re: Grading & Site Servicing Plan Review
Proposed Multi-Storey Building
1815 Montreal Road – Ottawa, Ontario

file: PG6594-MEMO.02

Figure 2 - Site Servicing Plan Review

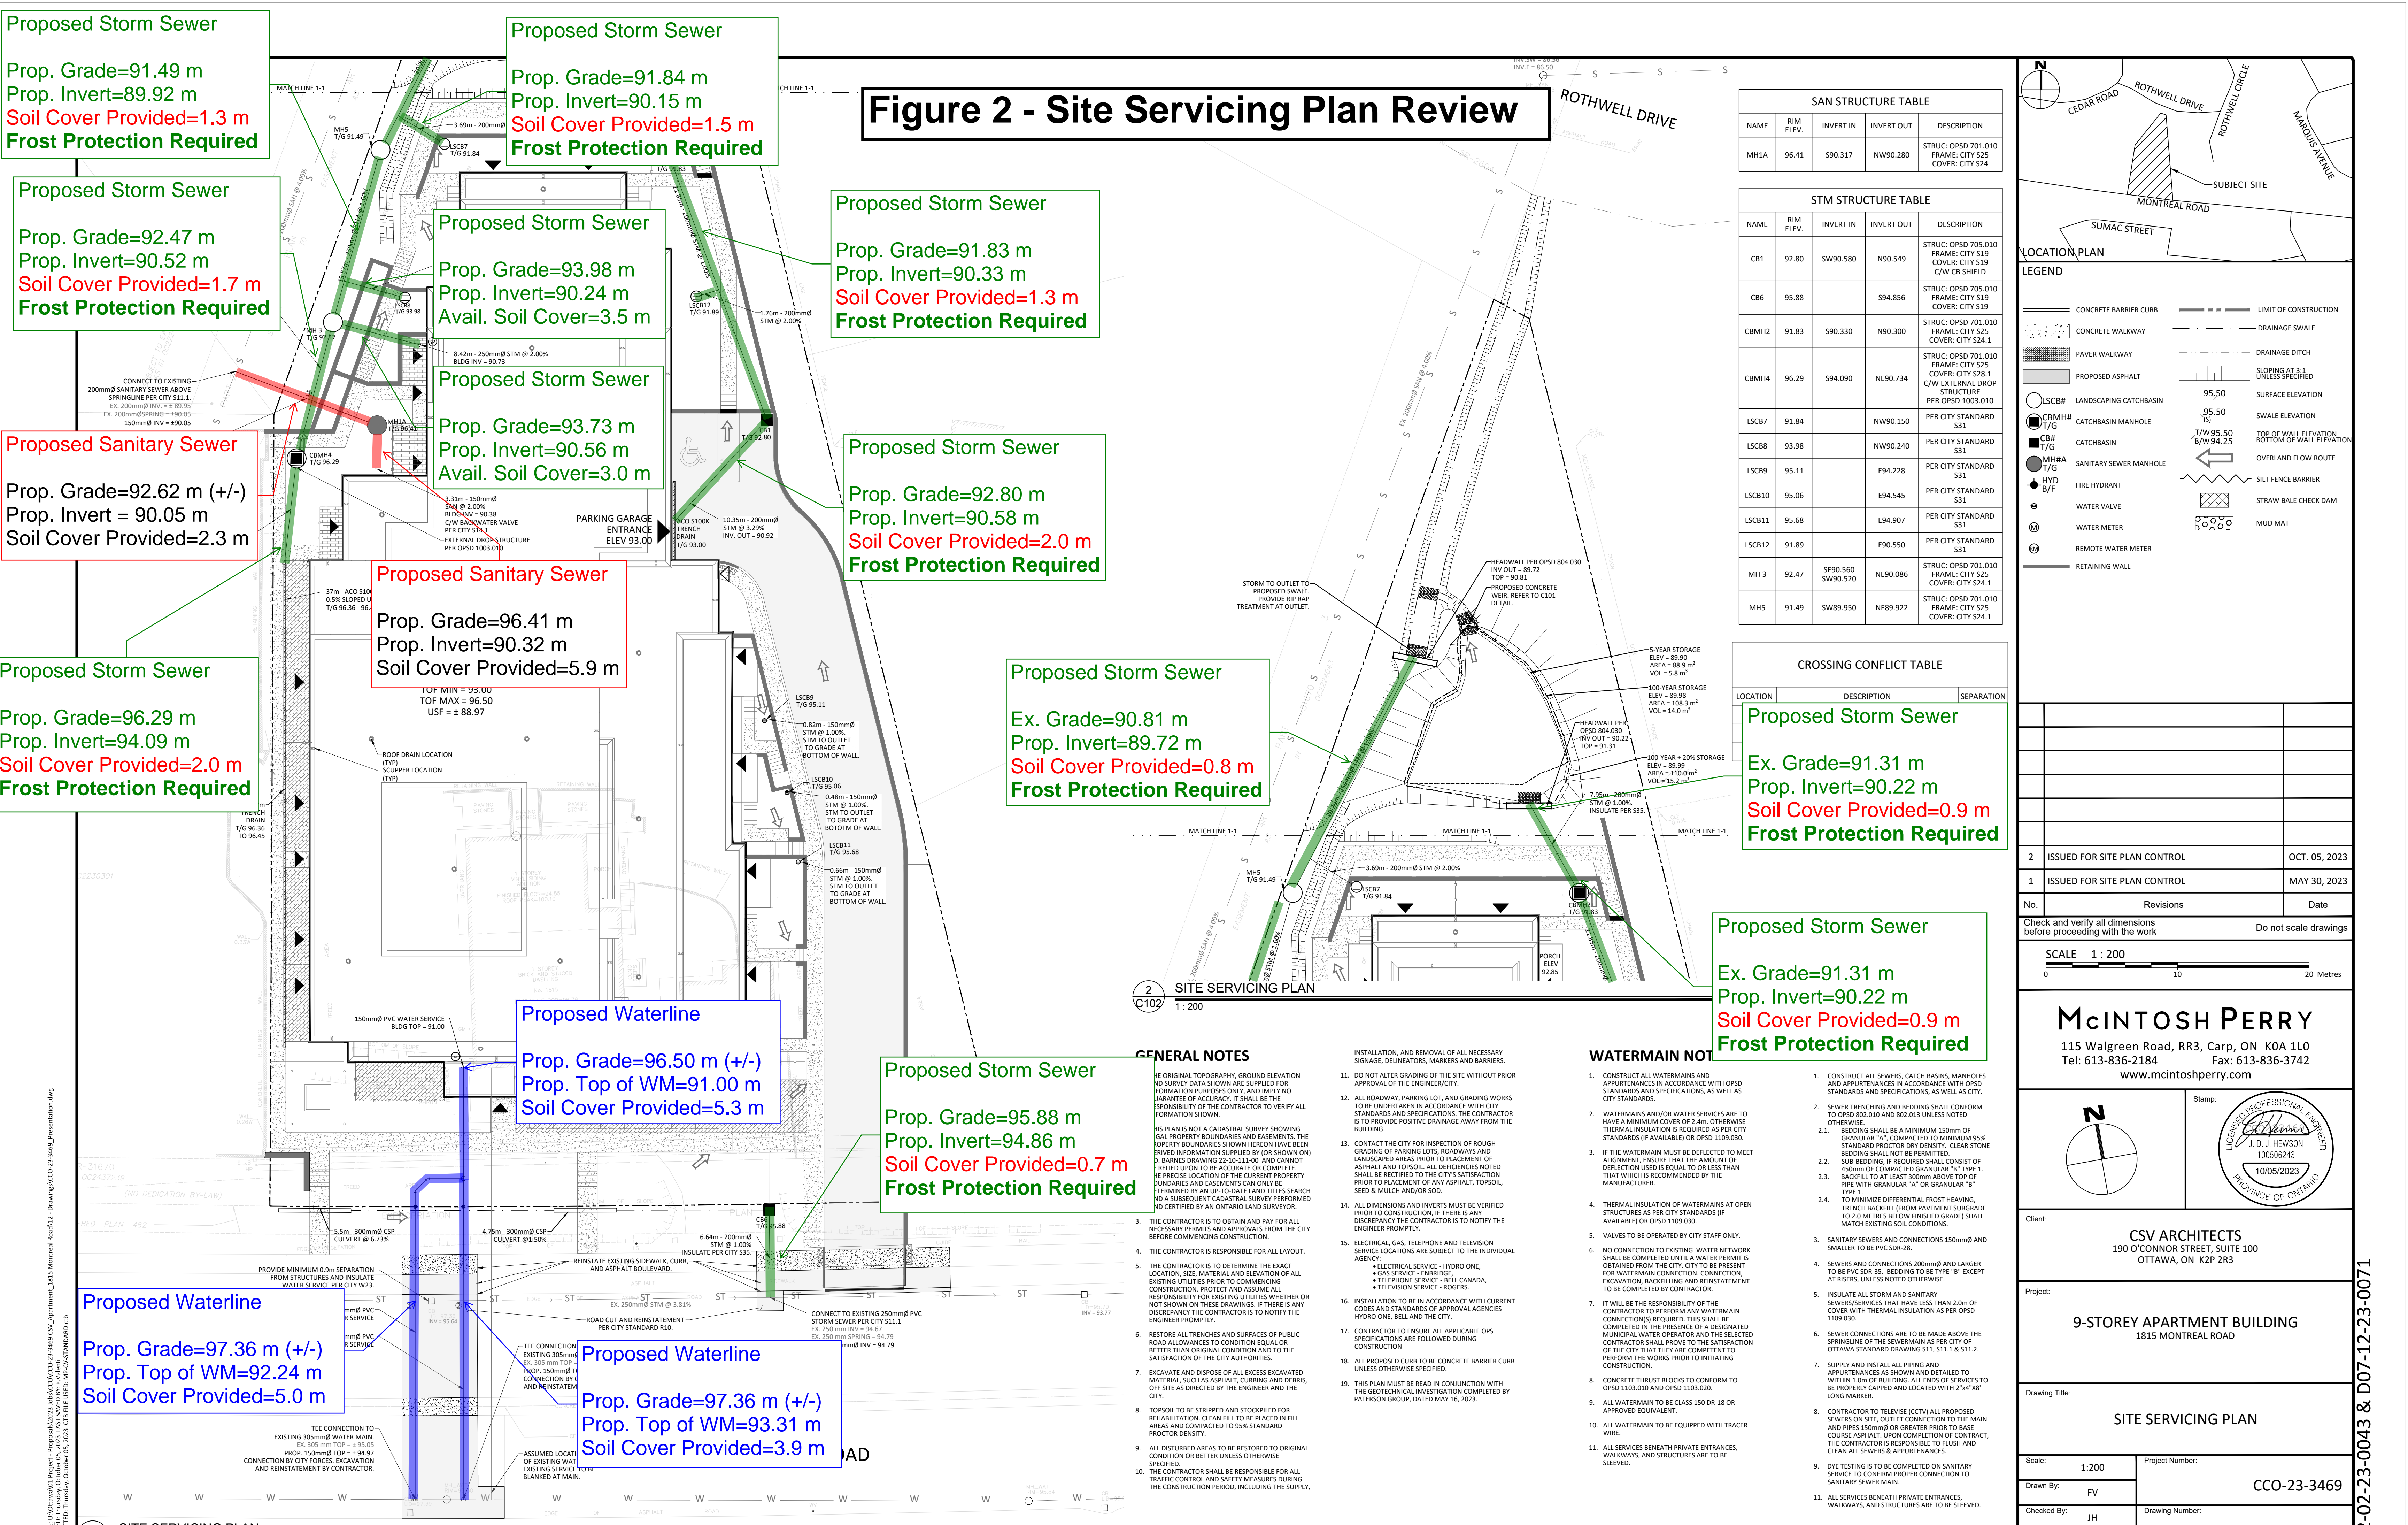
Based on our review of the site servicing plan, sufficient soil cover has been provided to the proposed watermain and sanitary services. However, insufficient soil cover was noted along segments of the proposed stormwater service. Where insufficient soil cover (i.e. less than 2.1 m of soil cover is present above the obvert of the pipe) is available, the following frost protection criteria outlined in Table 1 should be followed. Please refer to Figure 2 – Site Servicing Plan Review attached which indicates the frost protection provided to each service.

Proposed Storm Sewer
 Prop. Grade=91.49 m
 Prop. Invert=89.92 m
 Soil Cover Provided=1.3 m
 Frost Protection Required

Proposed Storm Sewer
 Prop. Grade=91.84 m
 Prop. Invert=90.15 m
 Soil Cover Provided=1.5 m
 Frost Protection Required

Proposed Storm Sewer
 Prop. Grade=92.47 m
 Prop. Invert=90.52 m
 Soil Cover Provided=1.7 m
 Frost Protection Required

Proposed Storm Sewer
 Prop. Grade=91.83 m
 Prop. Invert=90.33 m
 Soil Cover Provided=1.3 m
 Frost Protection Required

Proposed Storm Sewer
 Prop. Grade=92.80 m
 Prop. Invert=90.58 m
 Soil Cover Provided=2.0 m
 Frost Protection Required

Proposed Storm Sewer
 Prop. Grade=96.29 m
 Prop. Invert=94.09 m
 Soil Cover Provided=2.0 m
 Frost Protection Required

Proposed Storm Sewer
 Ex. Grade=90.81 m
 Prop. Invert=89.72 m
 Soil Cover Provided=0.8 m
 Frost Protection Required

Proposed Storm Sewer
 Ex. Grade=91.31 m
 Prop. Invert=90.22 m
 Soil Cover Provided=0.9 m
 Frost Protection Required

Proposed Storm Sewer
 Prop. Grade=95.88 m
 Prop. Invert=94.86 m
 Soil Cover Provided=0.7 m
 Frost Protection Required

Table 1 - Rigid Insulation Recommendations for Storm Sewer and Water Pipes with Reduced Soil Cover			
Thermal Condition	Soil Cover Provided (mm)	Insulation Dimensions	
		Thickness (mm)	Extension (mm)
Unheated	600 to 900	125	Extend 1200 mm horizontally beyond edge face of the pipe
	900 to 1200	100	Extend 1200 mm horizontally beyond edge face of the pipe
	1200 to 1500	75	Extend 900 mm horizontally beyond edge face of the pipe
	1500 to 1800	50	Extend 600 mm horizontally beyond edge face of the pipe
	1800 to <2100	25	Extend 300 mm horizontally beyond edge face of the pipe

All rigid insulation should consist of either Dow Chemical High-Load 40 (HI-40), Styro Rail SR.P400, or equivalent approved by Paterson. The placement of all insulation within the service trenches must be reviewed and approved by Paterson personnel at the time of construction.
